DESCRIPTIVE REPORT

Type of Survey ... Hydrographic
Field No. AHP-10-8-90
Registry No. H-10347

State New York
General Locality ... Long Island Sound
Sublocality Hempstead Harbor

DESCRIPTIVE REPORT TO ACCOMPANY
HYDROGRAPHIC SURVEY H-10347
FIELD NO. AHP-10-8-90
SCALE: 1:10,000
1990
ATLANTIC HYDROGRAPHIC PARTY TWO
CHIEF OF PARTY: LCDR V. DALE ROSS

CHART #12366

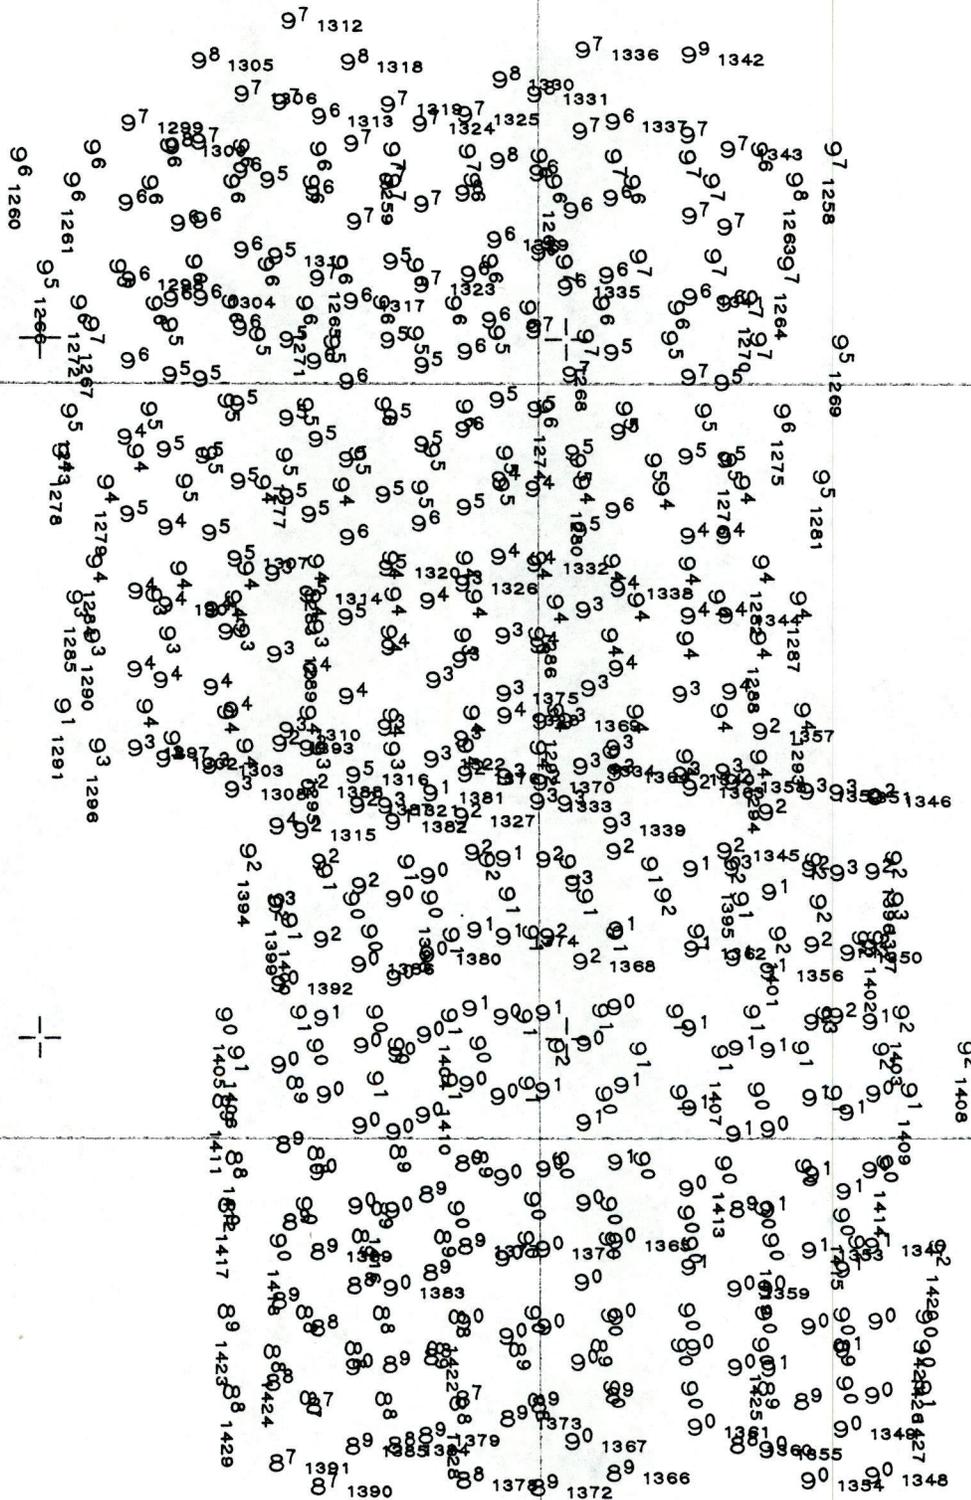
PRE-SURVEY REVIEW ITEM #6543
SOUNDING

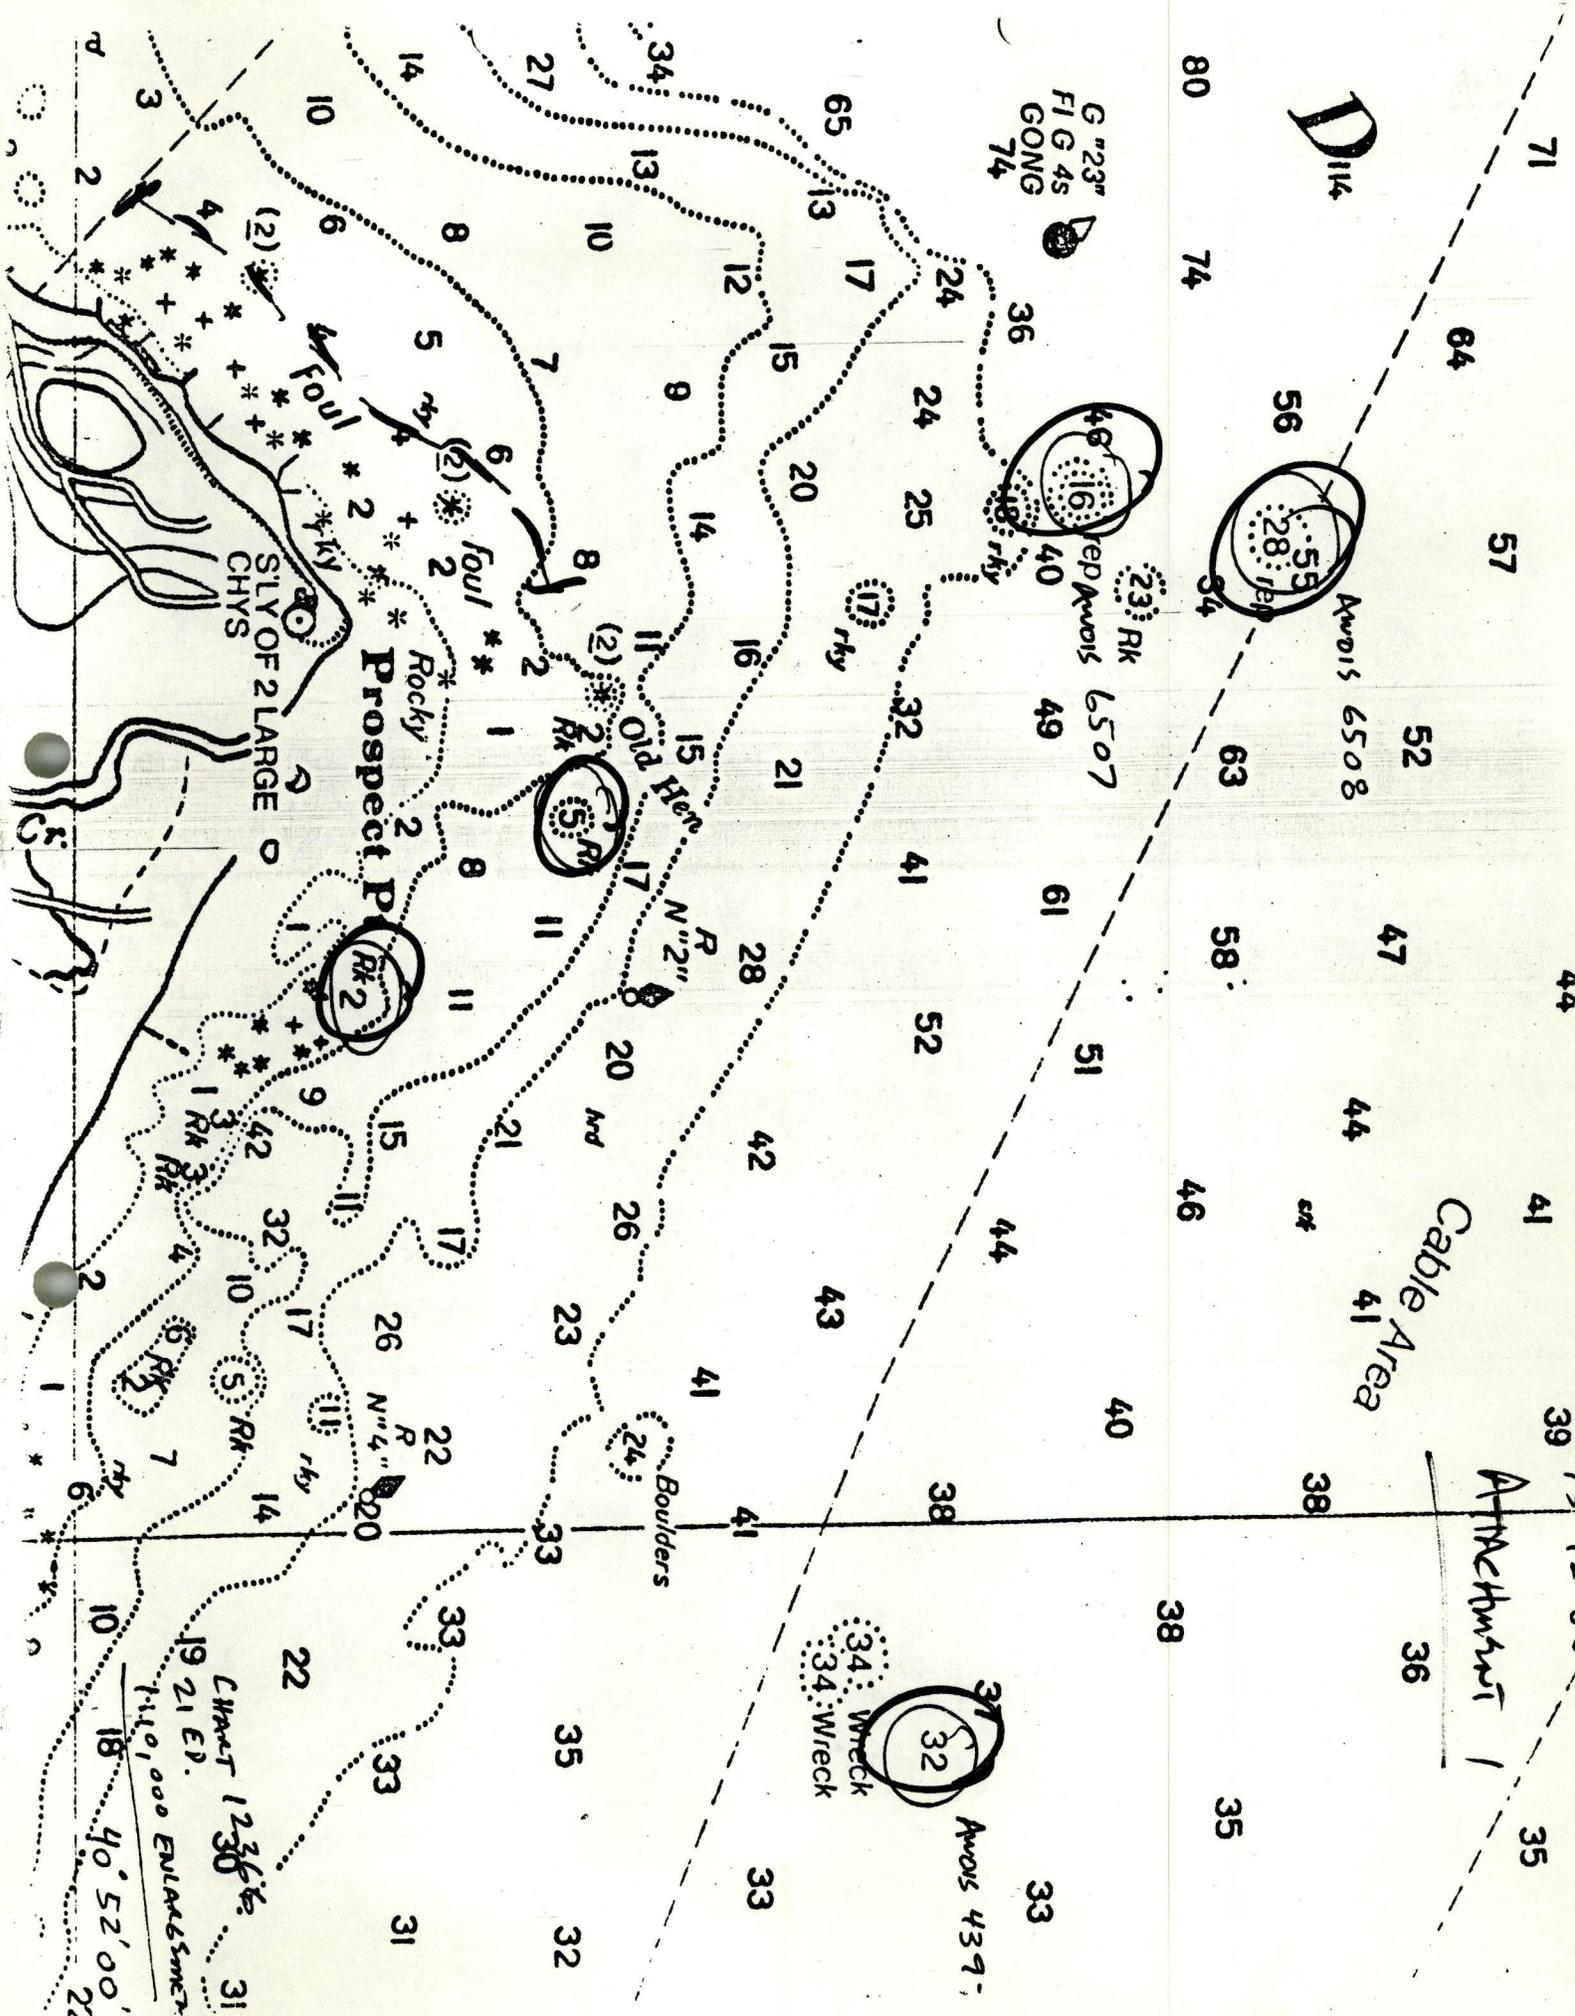
3. Investigate the 2 ft. submerged rock (Picket Rock) off Mott Point. The least depth found in the area on this survey is 2.1 m. X
